[Docket Nos. RM12-6-000 and RM12-7-000; Order No. 773]

Revisions to Electric Reliability Organization Definition of Bulk Electric System and
Rules of Procedure

ORDER NO. 773

FINAL RULE

Figure 1
Two Radial Systems Eligible for Exclusion E1

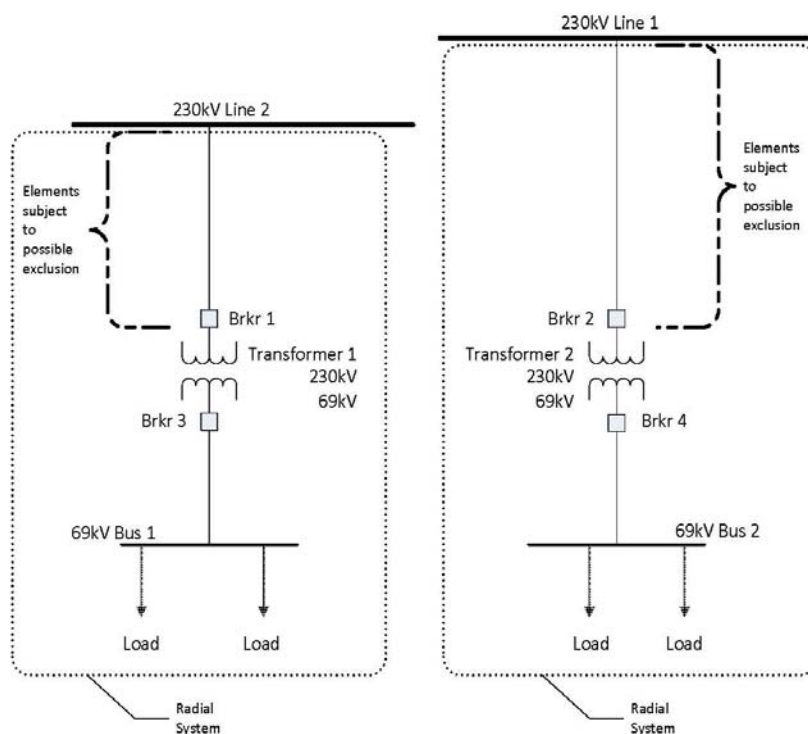
135. NERC and other commenters state that both radial systems depicted in figure 1 would be subject to exclusion E1(a) because they each only serve load.¹²⁶ ELCON agrees with NERC adding that these types of radial systems pose no reliability risk to the interconnected transmission network if the system is lost due to a fault condition. Similarly, SoCal Edison states that the figure 1 facilities would either be excluded or not

part of the bulk electric system. SoCal Edison asserts that, because transformers 1 and 2 each have secondary voltages that are less than 100 kV, they do not meet the inclusion I1 requirements and, thus, are not included in the bulk electric system. In other words, SoCal Edison believes exclusion E1 should exclude all radial facilities that are greater than 100 kV up to the point where “the system is no longer radial, as indicated in figure 1 by the brackets where the 230 kV lines meet [lines 1 and 2].”¹²⁷ APPA believes that all the scenarios described by the Commission could create reliability concerns “if taken in isolation and operated in a certain matter” and believes that the exception process can capture configurations that pose a significant risk to the reliable operation of the interconnected transmission network. Idaho Power maintains that it is inappropriate to apply exclusion E1 for 230 kV elements in the scenarios if the breakers are part of the protection scheme for a three terminal 230 kV line. Idaho Power adds that if either breaker only opens for transformer protection, the exclusion would be applicable.

136. Anaheim agrees that the radials shown in figure 1 should be excluded and requests clarification that the associated bus work and protection system equipment installed on those radial lines are also excluded. Anaheim advocates that the exclusion should also apply to protection system equipment on the excluded facilities that provide backup protection for devices that are part of the bulk electric system, i.e. lines 1 and 2 in figure 1.

140. The Commission agrees with NERC that the radial systems shown in figure 1 meet the definition of “radial system” in exclusion E1. This configuration would result in the 230 kV lines between transformers 1 and 2 to the two 230 kV lines, respectfully, being excluded from the bulk electric system. The Commission agrees with NERC and other commenters that both radial systems depicted in figure 1 would be subject to exclusion E1 condition (a) because they each only serve load.

Figure 2
Networked Configuration w/115 kV Loop

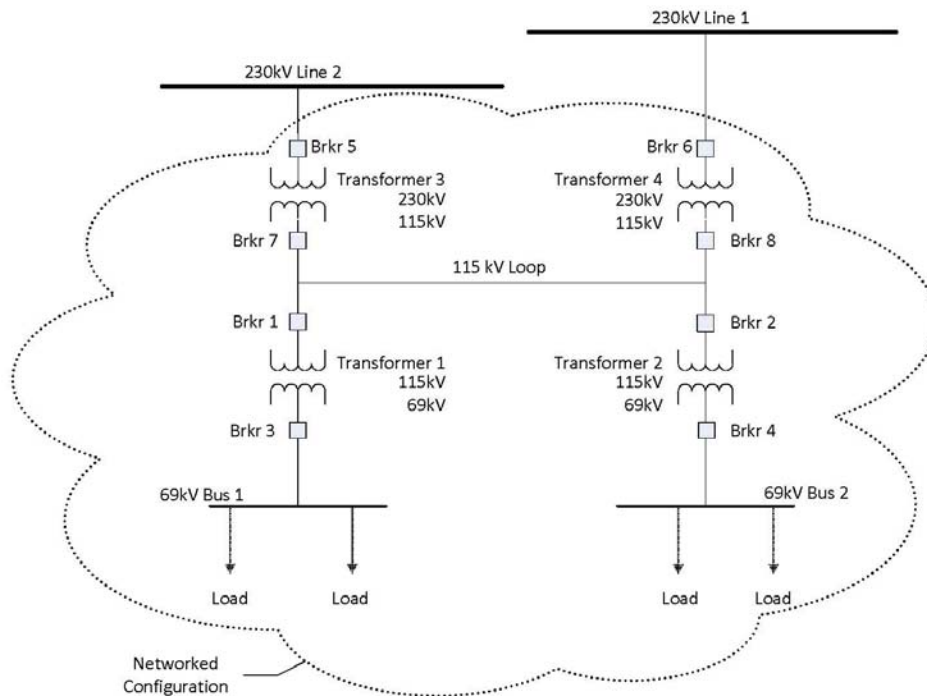
145. NERC states that figure 2 is a non-radial loop on the 115 kV system. According to NERC, the 115 kV elements above transformers 1 and 2 to the point of interconnection with lines 1 and 2 would not be eligible for exclusion E1 because they do not emanate from a single point of connection. NERC also states that it would be appropriate to evaluate figure 2 under exclusion E3 as a potential local network.¹³¹ For such a

146. Likewise, Idaho Power, ITC Companies, and National Grid contend that the figure 2 configuration should be included in the bulk electric system. Southern Companies believe exclusion E1 may apply from the breakers down and that the configuration may belong to exclusion E3. AEP assumes that each of the facilities below the 115 kV loop shown in figure 2, and including breaker 1 and breaker 2, are radial and excluded pursuant to exclusion E1. According to AEP, the facilities above breakers 1 and 2 may be excluded pursuant to exclusion E3 depending on the circumstances.¹³³

147. Valero states that the figure 2 configuration is very similar to common facilities configurations employed in many industrial facilities involving the interconnection of the industrial facility to the utility through two high voltage feeder lines that originate at different utility owned and operated substations. Valero requests that the Commission include in the final rule an additional exclusion that would “categorically exclude from the [bulk electric system] any on-site high voltage switchyard facilities (less than 300 kV) owned by the industrial end-user where the predominant function of the facilities is to

distribute electricity in an inward direction to the end-user's load.”¹³⁴ WPPC argues that figure 2 shows both radial and network systems and that the system from the 115 kV loop upwards would be assessed under exclusion E3 and below that point would be assessed by exclusion E1.

148. The Commission affirms NERC's statement that figure 2 is a non-radial loop and thus would not be eligible for exclusion E1 because it does not emanate from a single point of connection. The Commission agrees with commenters that the elements below the 115 kV loop should be assessed as two separate radial systems pursuant to exclusion E1. The remaining elements (the 115 kV loop, transformers 3 and 4 and the 230 kV tie lines above the transformers to the two 230 lines 1 and 2) should be assessed pursuant to exclusion E3 and if the configuration meets the criteria of exclusion E3, the elements could be excluded.

Figure 3
Networked Configuration w/69 kV Loop

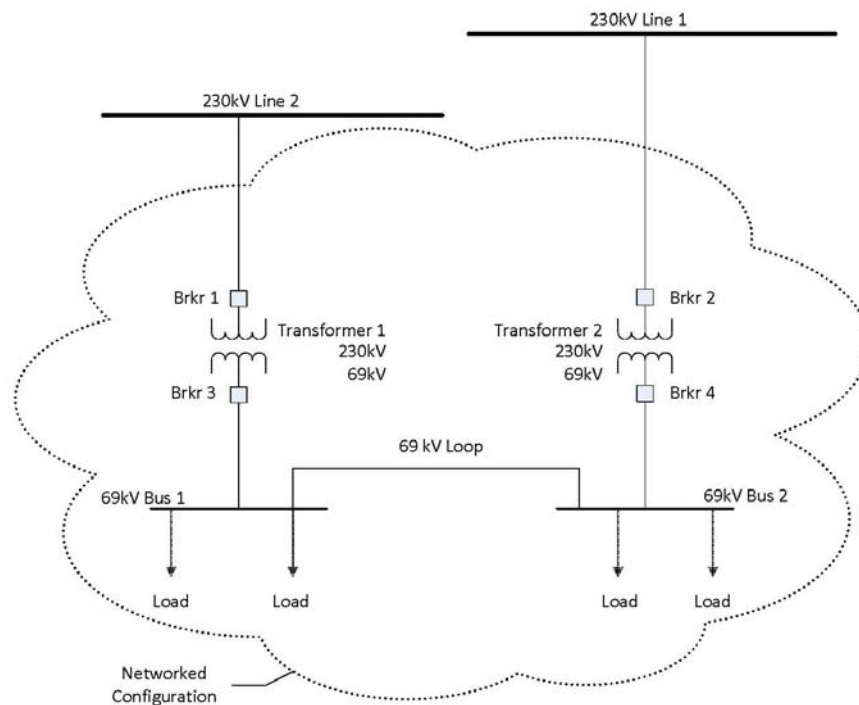
151. NERC disagrees with the Commission’s characterization of figure 3 in the NOPR. NERC states that figure 3 does not depict a configuration with two points of 100 kV or higher or a system emanating from two points of connection at 230 kV. According to NERC, except for lines 1 and 2, all the other elements depicted in figure 3 are excluded from the bulk electric system. NERC explains that the elements between line 1 and transformer 2 and from line 2 to transformer 1 are excluded by exclusion E1(a) because “each separate set of [e]lements [described above] is contiguous and emanate from a

153. Exelon agrees with NERC and explains that it has many connections similar to the one shown in figure 3 and provides a specific example where a 138 kV substation is fed by two radially connected 138 kV lines which in turn are connected through 40 MVA transformers to a 12 kV bus section. Exelon states that in its example the 40 MVA transformers cross bus sections so that if one of the 138 kV lines is out of service, each side of the 12 kV bus retains service. Exelon believes that due to the high impedance of the transformers, little energy flows between the buses in Exelon’s example.¹³⁸ Exelon

154. Other commenters believe that the figure 3 configuration may not be eligible for exclusion E1. SoCal Edison explains that the 69 kV loop is not open and therefore is a parallel path to the 230 kV system. BPA, Alameda and WREA do not view the figure 3 system as eligible for exclusion E1 because the system is networked. Idaho Power states that the 230 kV lines would be included only if there is a protection system in place for the 230 kV lines. According to Idaho Power, the elements above the transformers in figure 3 would not be excluded from the bulk electric system. Idaho Power believes this configuration should be evaluated under exclusion E3.

155. The Commission finds figure 3, which is identical to figure 5, is a networked configuration through a 69 kV loop and does not qualify for exclusion E1. The Commission also finds that, because the load in figure 3 can be served by either 230 kV line, it does not depict a “radial system.” However, the facilities below 100 kV may or may not be necessary for the operation of the interconnected transmission network, and this decision can be made case-by-case in the exception process. In other words, such facilities below 100 kV depicted in figure 3 would be excluded under the general threshold of the core definition unless found on a case-specific basis as necessary for the reliable operation of the interconnected transmission network. Thus, the Commission, while disagreeing with NERC’s interpretation, does not propose to include the below 100 kV elements in figure 3 in the bulk electric system, unless determined otherwise in

the exception process. Further, as we discuss below in connection with exclusion E3 and figure 5, while we find that the configuration shown in figures 3 and 5 would not be eligible for exclusion E1, we believe that such configurations should be eligible for exclusion E3 for local networks. However, exclusion E3 as written requires the candidate local network to be contiguous and above 100 kV, thus, the exclusion E3 language as written does not allow for figures 3 and 5 to be eligible for the local network exclusion because they are not contiguous *and* include facilities that are not above 100 kV. Therefore, we direct NERC to modify exclusion E3 to remove the 100 kV minimum operating voltage in the local network definition. This modification will enable configurations similar to figures 3 and 5 to be assessed for the local network exclusion. The Commission believes this modification, together with satisfying the criteria outlined in exclusion E3, will appropriately exclude local network configurations that are not necessary to the reliable operation of the interconnected transmission network.¹³⁹

Figure 5
Networked Configuration w/69 kV Loop

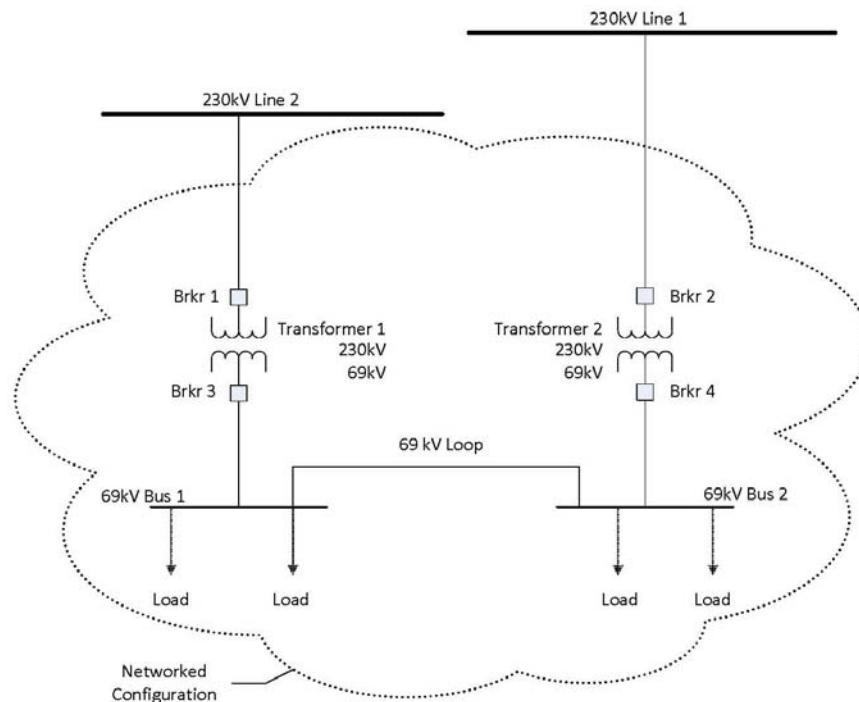
195. In the NOPR, the Commission stated that figure 5 depicts a group of elements that are contiguous through a 69 kV loop and requested comment whether the configuration in figure 5 qualifies as a local network and, in particular, whether the configuration satisfies the conditions that a local network be contiguous and operated at or above 100 kV.

196. NERC views figure 5 the same as figure 3 - as a looped system below 100 kV - that is not considered under this exclusion because the elements below 100 kV are

presumed to be not part of the bulk electric system.¹⁶⁷ NERC maintains that, if it is determined that the sub-100 kV looped system is necessary for the reliable operation of the interconnected transmission network, the exception process may be utilized to include the appropriate elements. NERC states that figure 5 depicts two separate and distinct groups of elements that each emanate from a single point of interconnection at 230 kV and only serve load. Accordingly, NERC states that 230 kV lines 1 and 2 are included in the bulk electric system with the only other included elements being the lines extending from lines 1 and 2. However, according to NERC, the elements between 230 kV line 1 and transformer 2 and between 230 kV line 2 and transformer 1 are each subject to exclusion E1(a) because each separate set of elements is contiguous and emanate from a single point of connection of 100 kV or higher. NERC asserts that the elements below the 69 kV side of transformers 1 and 2 are excluded because they are less than 100 kV. NERC explains that transformers 1 and 2 are excluded because they bridge voltages of 69 kV and 230 kV and therefore, inclusion I1 is not applicable because a transformer must have two terminals over 100 kV to qualify for inclusion I1. According to NERC, the definition should focus on looped or networked connections at 100 kV or greater because such connections, when operated below 100 kV, generally do not carry

197. Exelon states that the clear intent of the definition is that configurations such as shown in figure 5 are radial systems subject to exclusion E1 (radial systems). According to Exelon, had this not been the intent of exclusion E1, exclusion E3 would have allowed for a local network where the tie was below 100 kV to avoid a reliability gap. Exelon believes that the configuration shown in figure 5, which is identical to figure 3, does not qualify as a local network within the terms of exclusion E3 and supports NERC's view that figure 5 represents two radial systems that qualify under exclusion E1. Exelon cautions that, if the Commission determines that the systems depicted in figure 5 do not qualify under exclusion E1 because of the low voltage tie and does not qualify under exclusion E3 because the tie is at low voltage and not a 100 kV or above, such a decision would leave a gap under which a substantial number of facilities that are not part of the bulk electric system would be classified as such. Exelon states that it would have to go through the separate exception process for dozens of substations, at great cost and for no useful purpose. Exelon states that the Commission should clarify that the configuration shown in figures 3 and 5 qualifies as a radial system and is excluded pursuant to exclusion E1.

199. As discussed above, the Commission is directing a modification to exclusion E3 to better capture local networks like those depicted in figure 5. The Commission notes that Exelon believes that the configuration shown in figure 5, which is identical to figure 3, does not qualify as a local network within the terms of exclusion E3. While figures 3 and 5 are a networked configuration through a 69 kV loop, they do not qualify for the local network exclusion because exclusion E3 defines local networks as “[a] group of contiguous transmission Elements operated at or above 100 kV but less than 300 kV that distribute power to Load rather than transfer bulk-power across the interconnected system.” The configuration in figure 5 includes elements that are below 100 kV, and does not have contiguous elements operating at or above 100 kV but less than 300 kV. As noted above, while the Commission finds that these configurations should not be eligible for exclusion E1, we believe that they should be eligible for the local network exclusion. Therefore, we direct NERC to modify exclusion E3 to remove the 100 kV minimum operating voltage in the local network definition. Within 30 days of the effective date of this Final Rule, we direct NERC to submit a schedule outlining how and when it will make the modification to the definition.
